BLDG PERMIT NO. 64815

PLANNING CLEARANCE

BLDG ADDRESS 2385 Pleasant Ridge FAX SCHEDULE NO. 2945-174-33-021
 SUBDIVISION Pleasant Ridge SQ. FT. OF PROPOSED BLDG(S)/ADDITION 1,921
 FILING 6 BLK LOT 21A SQ. FT. OF EXISTING BLDG(S) 0
 (1) OWNER Robert Bollinger NO. OF DWELLING UNITS
 BEFORE: 0 AFTER: 1 THIS CONSTRUCTION
 (1) ADDRESS 395 Ridgeway Dr
 (1) TELEPHONE 970-255-1575 NO. OF BLDGS ON PARCEL
 BEFORE: 0 AFTER: 1 THIS CONSTRUCTION
 (2) APPLICANT Same USE OF EXISTING BLDGS
 (2) ADDRESS DESCRIPTION OF WORK AND INTENDED USE: Home
 (2) TELEPHONE

► APPROVAL FOR BUILDING PERMIT ◀
 Ridges Architectural Control Committee (ACCO)

Site Plan

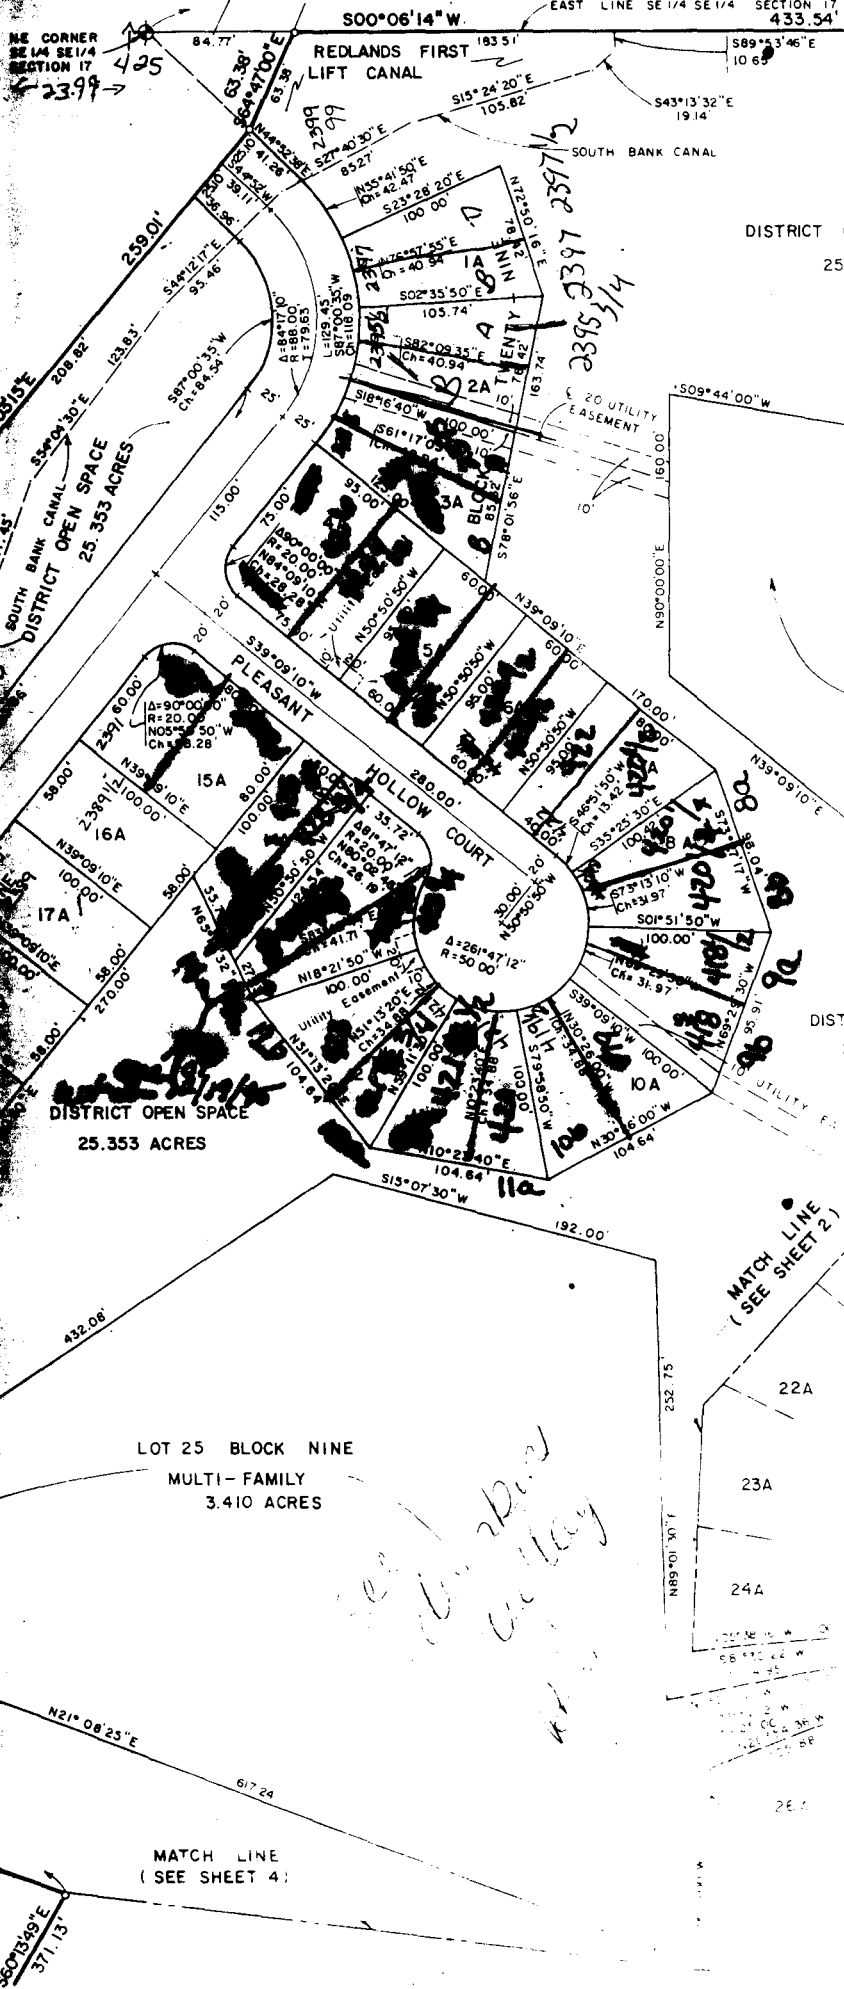
49' Revised
56-98 & P&R
ACCEPTED ANY CHANGE OF SETBACKS MUST BE APPROVED BY THE CITY PLANNING DEPT. IT IS THE APPLICANT'S RESPONSIBILITY TO PROPERLY LOCATE AND IDENTIFY BASEMENTS AND PROPERTY LINES.

Concrete Retaining wall here

All drainage in existing grad

DRIVENAY LOCATION OK
4/20/98
Be advised
